Number	Description
1	Revised Table of Contents; Revised NTB Nos. 458, & 459; Added NTB No. 460; Revised Bid Items; Revised or Added Plan Sheet Nos. 2,8-10,17,3001,3004,3006,3013-3017, & 3020; Amendment EBS Download Required.

MISSISSIPPI DEPARTMENT OF TRANSPORTATION
TABLE OF CONTENTS

PROJECT: HSIP-0003-01(192)/107127301 - Hancock

ADDENDUM

SHEET NUMBER: 3001

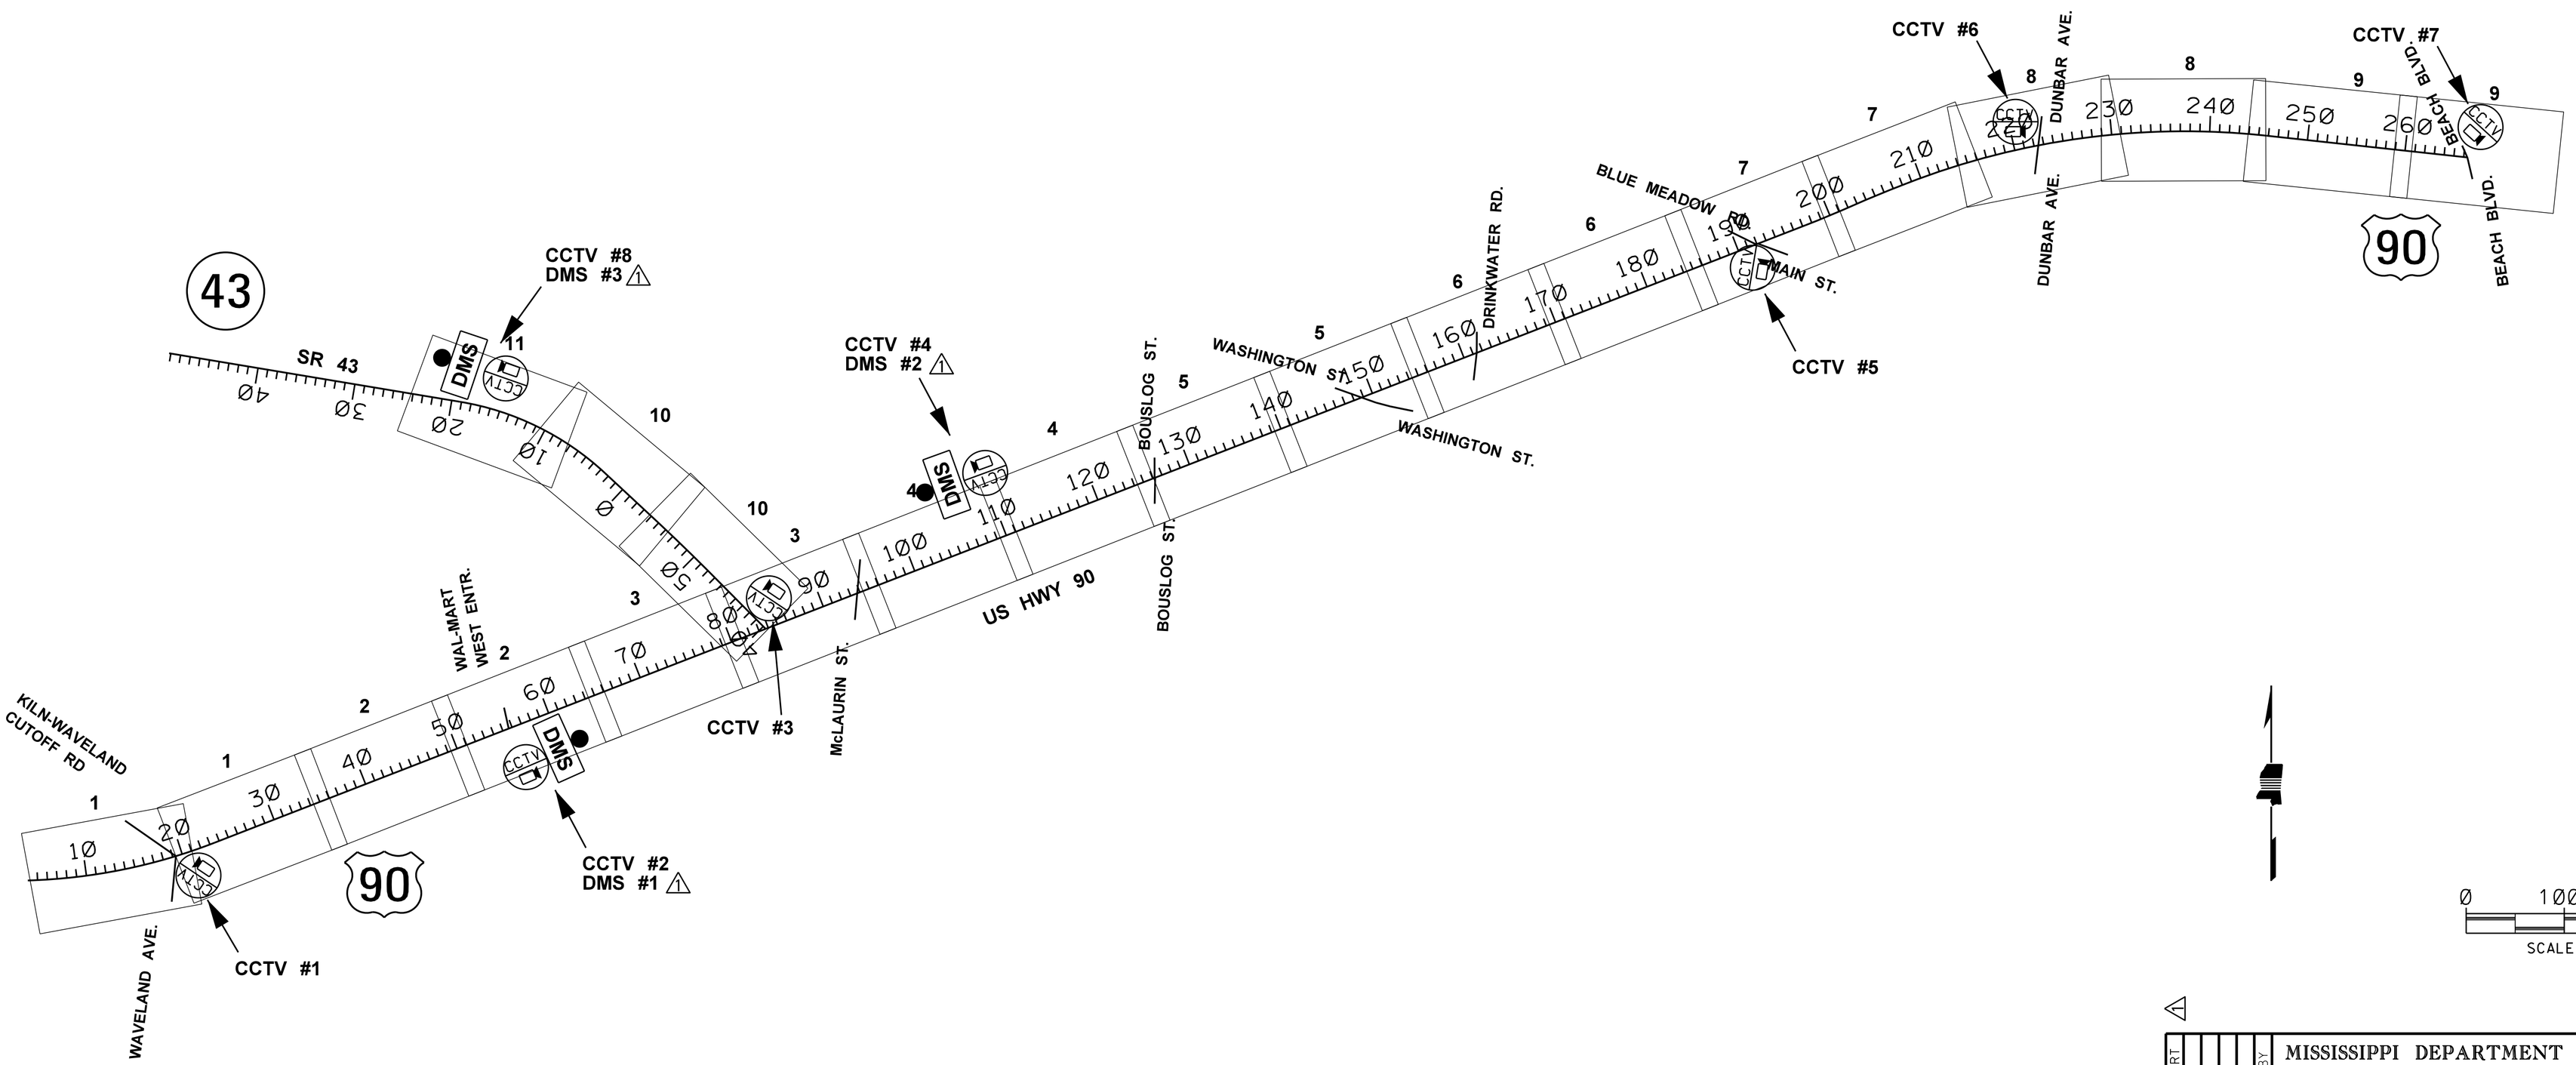
WR-T		BY	MISSISSIPPI DEPARTMENT OF TRANSPORTATION
DMS SIGN NUMBERS CHANGED		REVISION	**ITS PLAN**
			PROJECT LOCATION PLAN
			COUNTY: HANCOCK
			PROJ. NO.: HSIP-0003-01(192)
05-15-18		DATE	FILENAME: LP-1.DGN
			DESIGN TEAM_____ CHECKED_____ DATE_____

SHEET NUMBER 3006

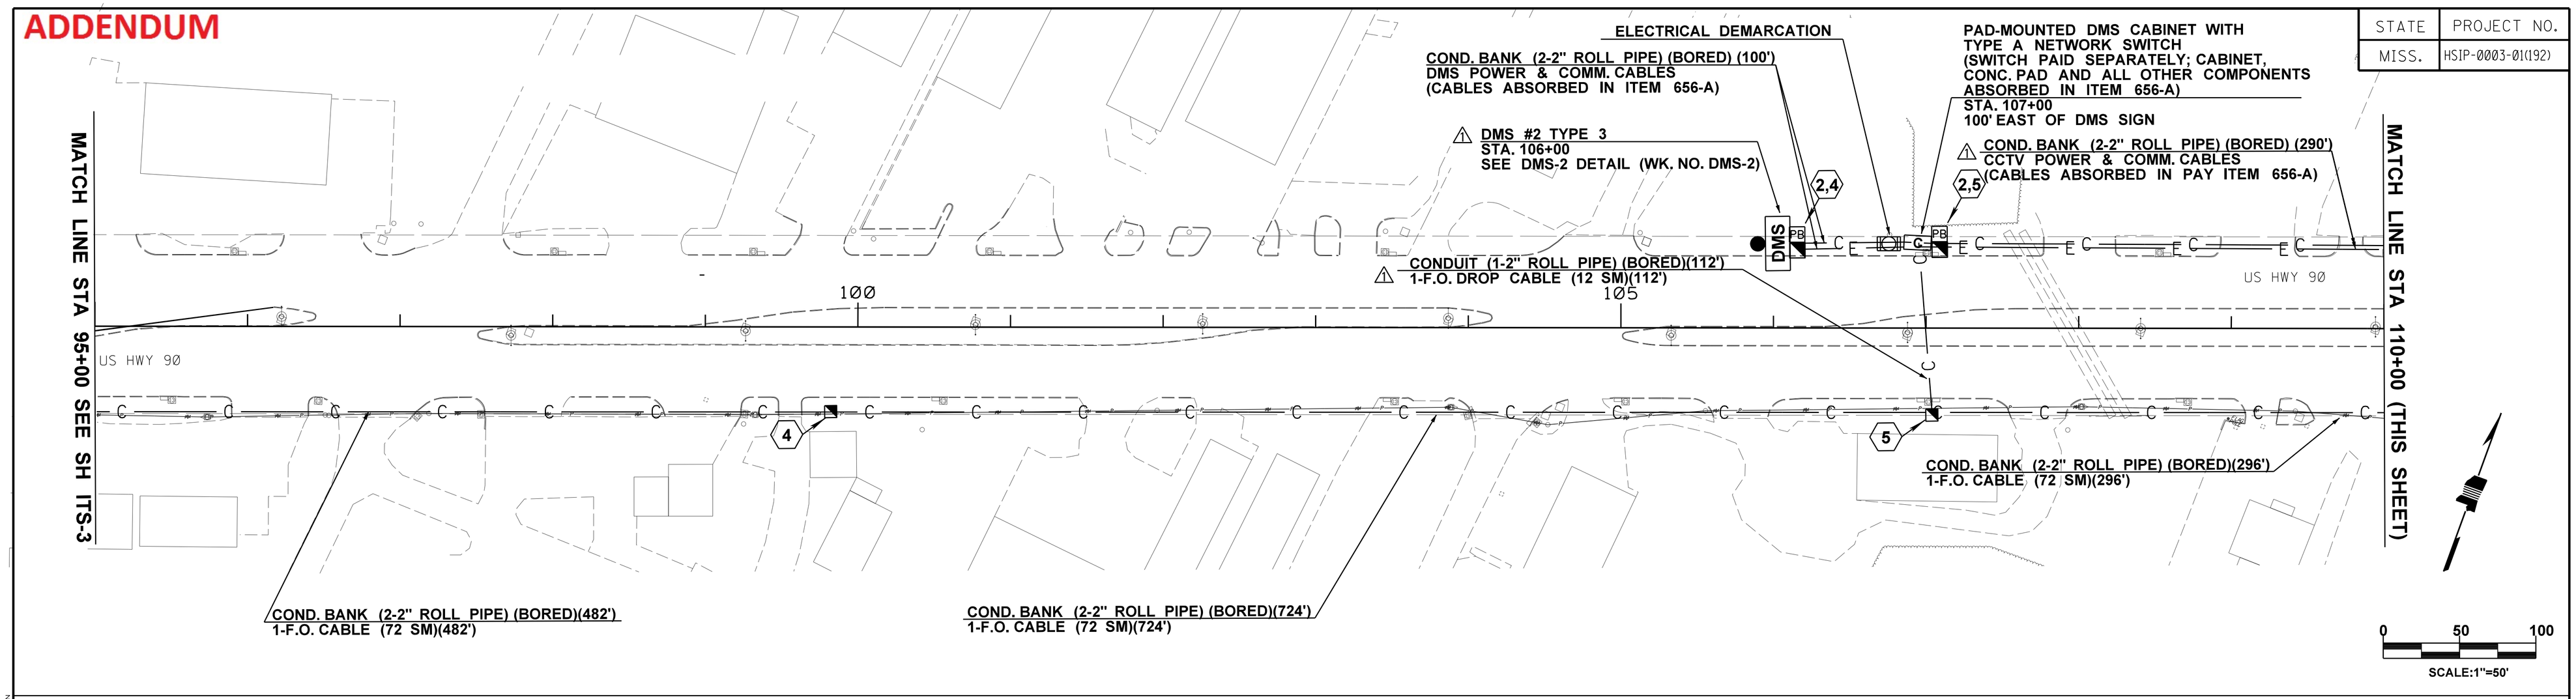
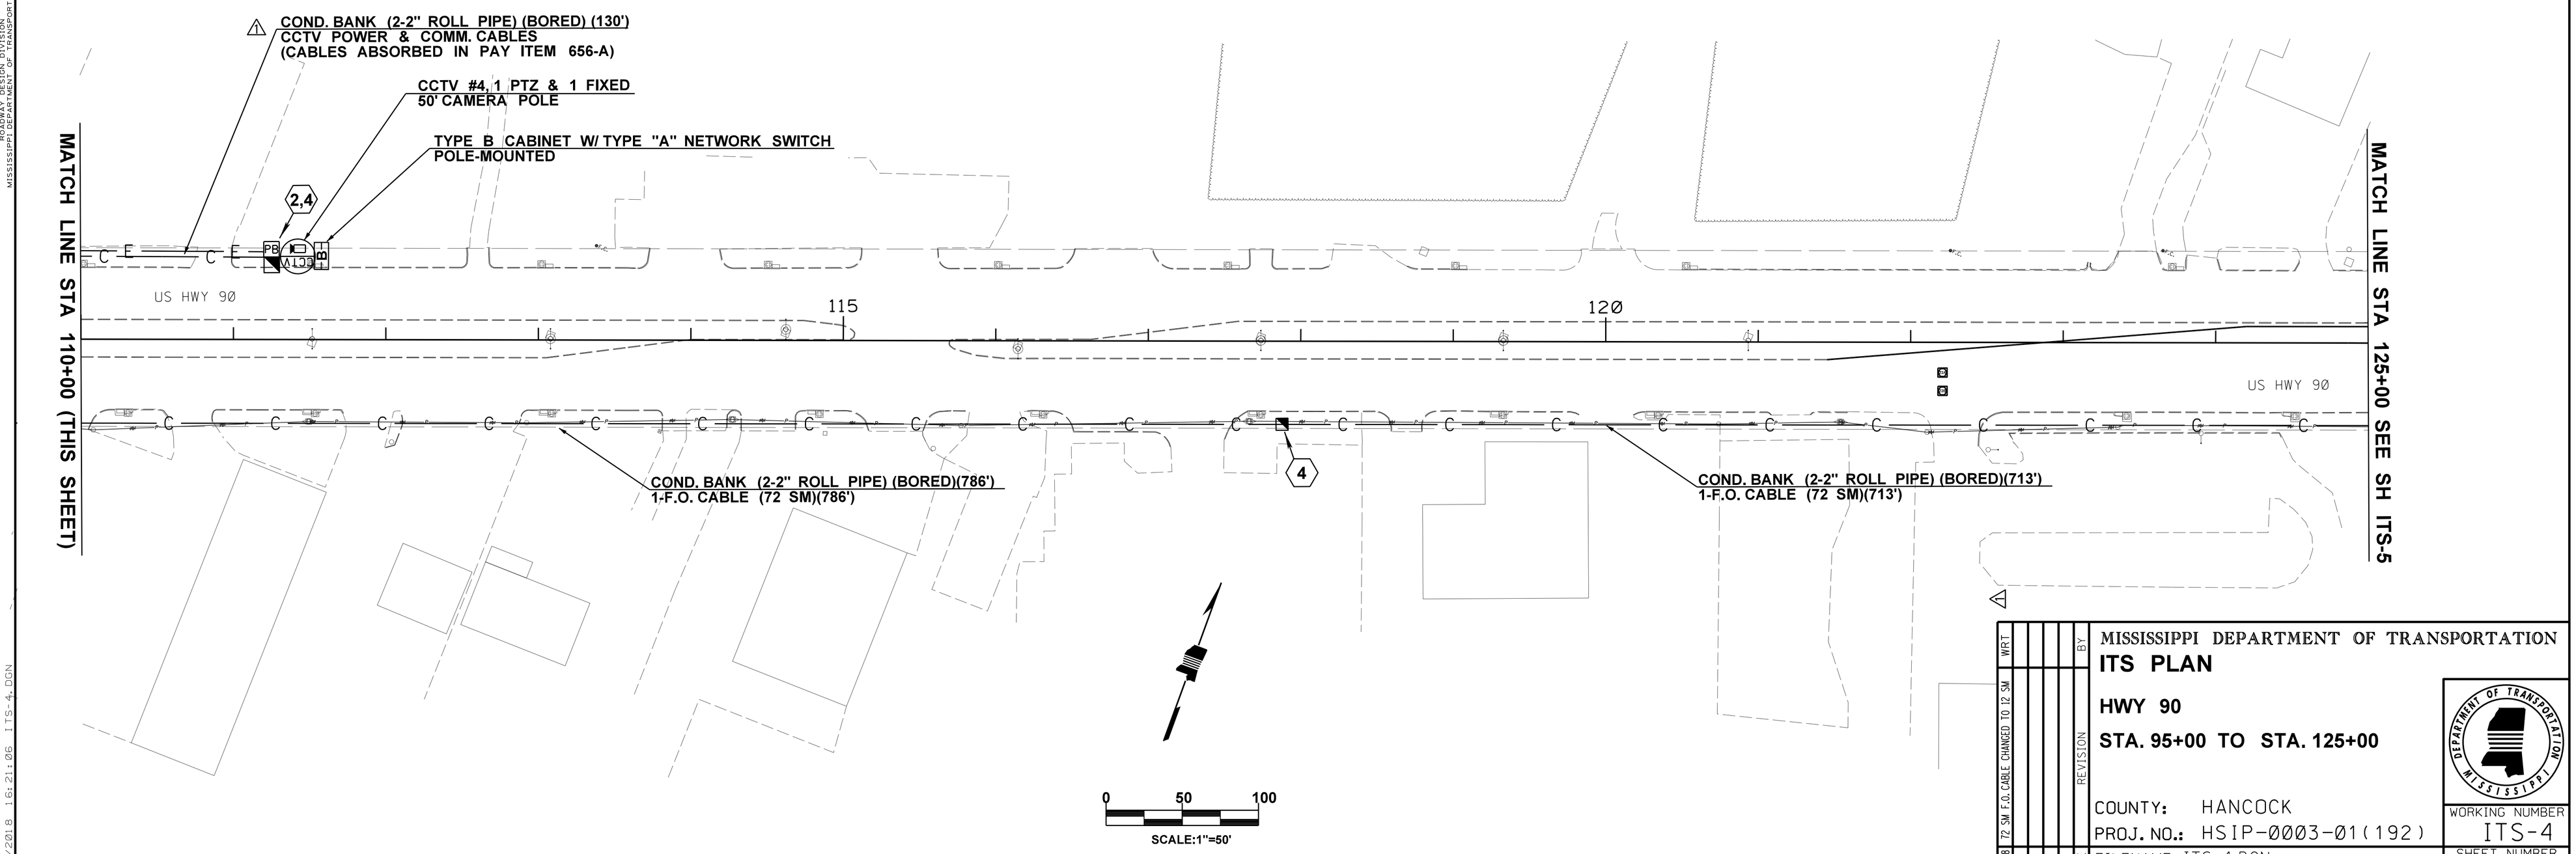
DATE	REVISION	BY
05-15-18	12 SM F.O. CABLE CHANGED TO 12 SM	WRT
